Accessibility Audit of Footpaths and Public Hospitals in Dhaka (North and South) City Corporation Areas

Jan 2022

Prepared by

The Centre for Disability in Development (CDD)

Pic-18: Counters are not wheelchair user friendly

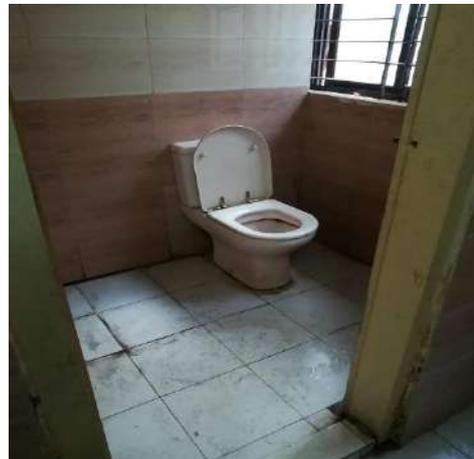
Pic-17: No reserved booth for persons with disability, senior citizens were seen in the Ticket & cash counter

Pic-22: Stair alongside the corridor

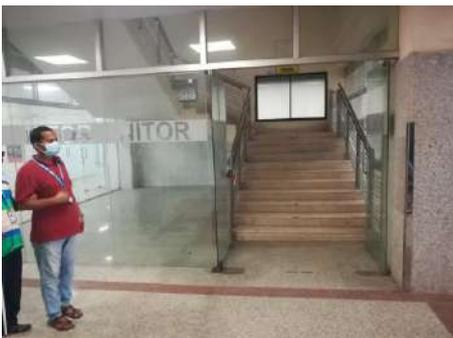
Findings	Gaps	Recommendations
<p>The corridor is 5182mm wide. The surface of the corridors is stable, flat, non-slip and non-glare. Corridors door meet the accessibility requirements. It is a glass-made swing door. This door opens inward and has a clear open space of 1737mm. The door handle is 305mm, D-shape. The handle position is between 965mm to 1270mm from floor level. The stair along the corridor does not meet the accessibility standards, Pic-22.</p> <ul style="list-style-type: none"> • Width: 1829mm • Steps 127mm high and 305mm deep. • No appropriate color contrast • Handrails are continuous, at both sides and 991mm in height. • Landings 1829mm in length and 2134mm in wide. <p>There are ramps alongside the corridors, do not meet the accessibility requirements.</p> <ul style="list-style-type: none"> • Type of ramp: 180-degree turn • Width: 1981mm • No handrails present <p>Landings are present after every 25298mm vertical rise, Length 4816mm and 2896mm width</p>	<p>Corridors are not free from obstacles and hazards. Patients and their attendants are flooring in the corridor. Obstacles are not contrasting colors in the corridor. There are no clear signs and pictographs providing directions to rooms, elevators, and stairs with color contrast, non-glare, large print and pictures. There is no tactile paving with color contrast. Light intensity is low along with the landings and corridors. No functioning audio-visual fire alarms. No clear signage and pictograph indicating accessible escape routes.</p> <p>Some signboards/ directions are handwritten and too small to notice No proper indicators for visually impaired individuals.</p>	<p>Any obstacles in the corridor area shall be avoided. All obstacles shall be appropriate colour contrasted with the background. Use appropriate signage and indications. Signage shall comply with 3.4.1.1. Outside of the hospital, page-12. Install appropriate colour contrasted tactile indicator comply with Fig-03, Annexure-02. Increase the lighting to a maximum of 11 LPD (w/m^2). Install an audible and visible emergency alarm system and clear directional signage of accessible escape routes. Stair shall be altered into accessible stair complying with section 3.4.1.3. Entrance - Stairs, page-15. The ramp shall be altered and comply with 3.4.1.3. Entrance - Ramps, page-15.</p>

Pic-59: Foot over bridge do not have appropriate connecting routes

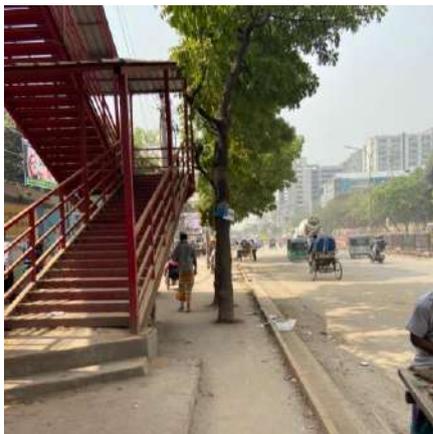
Findings	Gaps	Recommendations
<p>There is a Foot-over-bridge in the vicinity. There is an uneven pathway, broken towards the foot over bridge that measures 1066mm. Pic-59 There are 23 stairs and then mid-landing. The stair is dog-legged. Pic-60 On a single flight of stairs, the riser heights and tread widths are not uniform. Tread: 280mm or 264mm Riser: 100mm or 152mm There are no detectable warnings at the stairs. There is no nosing. The handrails are not continuous along both sides of the stairs. Gripping spaces are interrupted. Ends of handrails are not properly treated. Height of the handrails 1066mm The handrails are not circular. Mid-landing after 23 steps and 26 steps before the main landing. Mid-landing measures 3454mmx1600mm. The width of the stairway is 1500mm. There is no tactile ground surface indicator at every top and bottom of landings. There are light fixtures at every landing. There are no proper signage/ indicators for visually impaired individuals The staircase is prone to accumulating water The bridge circulation space is 2640mm. Ground coverings are not non-slip and well-drained</p>	<p>Stairs are uneven, broken and poor maintenance. The stairs are not properly constructed and can cause tripping. Handrails are interrupted by posts at intervals. Handrails are discontinued after the landing which may cause disruption. Even though there are 8-10 light fixtures on the foot over bridge, the lighting is insufficient for the nighttime. Huge crowd collision while climbing the stairs. The landings after 25 steps on a single flight can cause exhaustion and are not standard. The foot over bridge is not one way up” and one way down” and it is not possible to ensure this to avoid a severe collision.</p>	<p>4.1. Alter an accessible pathway shall comply with 2.1, page 62. 4.2. Stairs shall comply with section 3.4.1.3. Entrance - stairs, page-6. 4.3. Install appropriate signage shall comply with section 3.4.1.1. Outside of the hospital, page-6. 4.4. Ensure sufficient lighting on the over bridge.</p>

Pic-60: Initial steps are too high
